## COMMENTS ON THE COMPETITIVENESS OF GRAIN ORIENTED ELECTRICAL STEELS AT HIGHER dELs

### 2. RESULTS FROM AK STEEL DL-1 MODELING

**Impact of dELs and A-Factor on the Price Parity of M-3 RGO vs  
Amorphous Metal in a DL-1 Distribution Transformer**

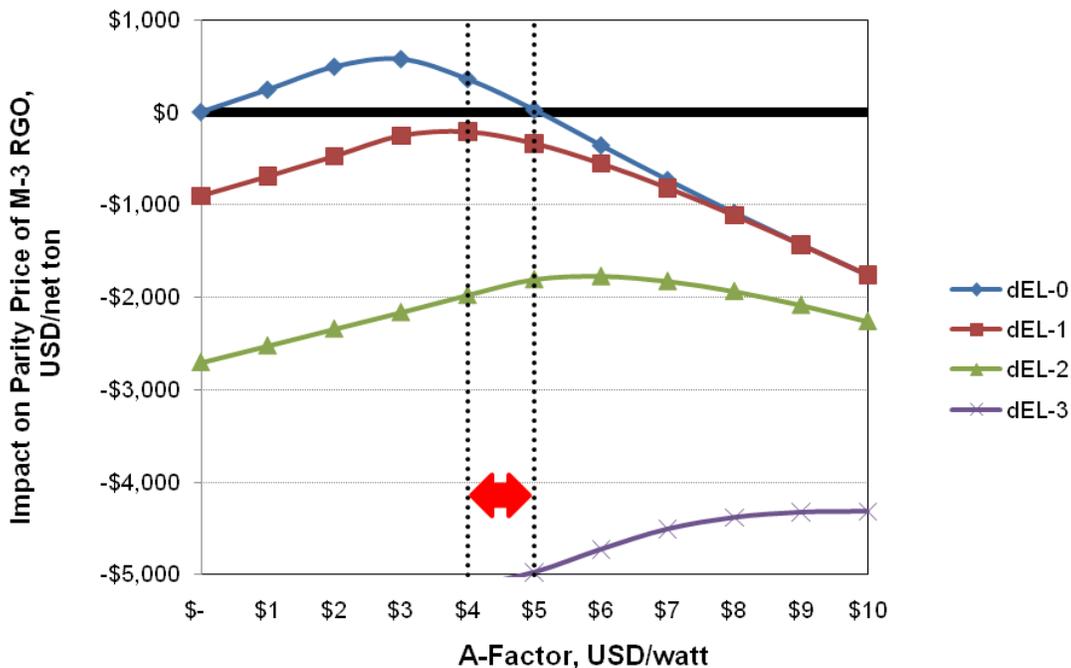
The figure below shows the results from our DL-1 model for M3. The red arrow shows what we believe is a typical range for A-factor in dEL-0 compliant units.

Our model suggests that at dEL-0, M3 is competitive with SA1 at A-factors up to \$5/w, falling rapidly in value thereafter. At dEL-1, the competitiveness of M3 is significantly impacted regardless of A-factor. At dEL-2, M3 is uncompetitive. At dEL-3, M3 would have to be supplied at, essentially, zero cost.

**Impact of dELs and A-Factor on the Price Parity of M-2 RGO vs Amorphous Metal in a DL-1 Distribution Transformer**

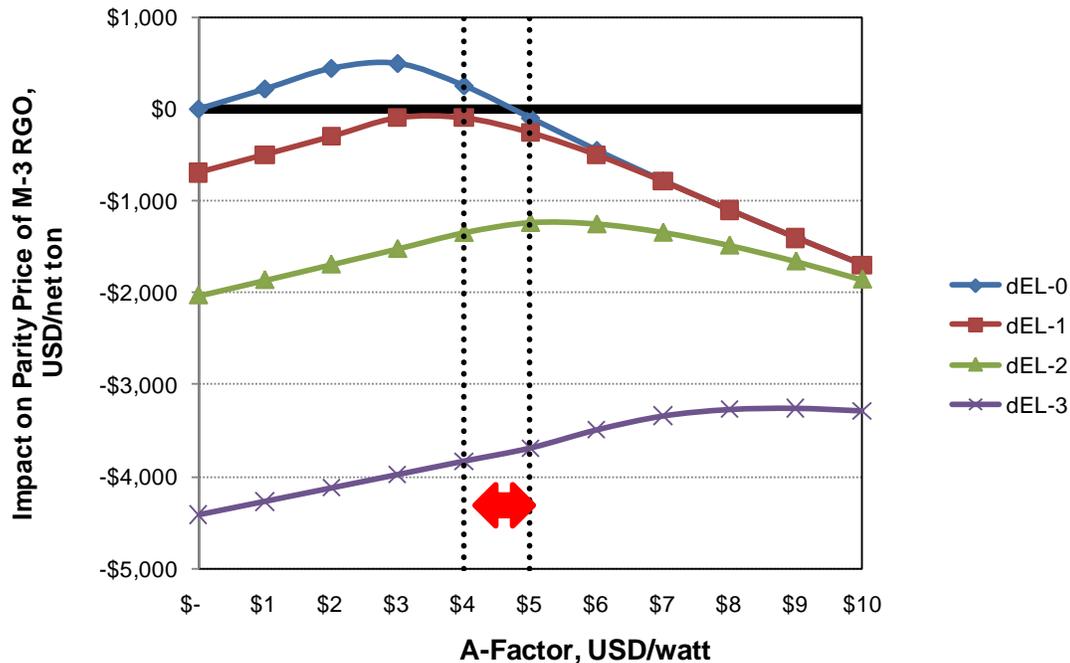
The figure below shows the results from our DL-1 model for M2.

Our model suggests that at dEL-0, M2 is slightly more competitive with SA1 than M3 at A-factors up to \$5/w; however, it also falls off rapidly in value thereafter. At dEL-2, M2 is uncompetitive across the entire spectrum of A-factor. At dEL-3, M2 would have to be supplied at, essentially, zero cost.
